Service Letter No. 419

SUBJECT: Inspection of Heater Air Distribution Box Attachment Screws

MODELS AFFECTED: PA-30 Twin Comanches, Serial Numbers 30-1 to 30-278 inclusive.

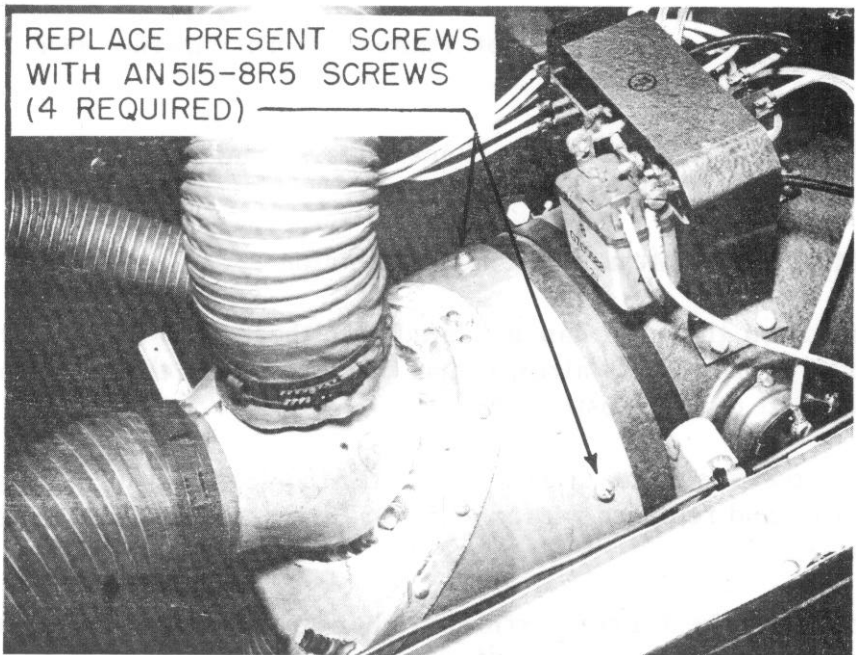
A report from the field has indicated that the heater air distribution box attachment screw in the subject aircraft may project through the heater outer shell far enough to contact the combustion chamber.

The area of the heater combustion chamber directly under the four (4) screws should be checked for possible chafing at the time the screws are changed.

In order to correct this situation, the AN515-8R6 screw presently installed should be removed and replaced with an AN515-8R5 screw. See sketch on the reverse side of this letter.
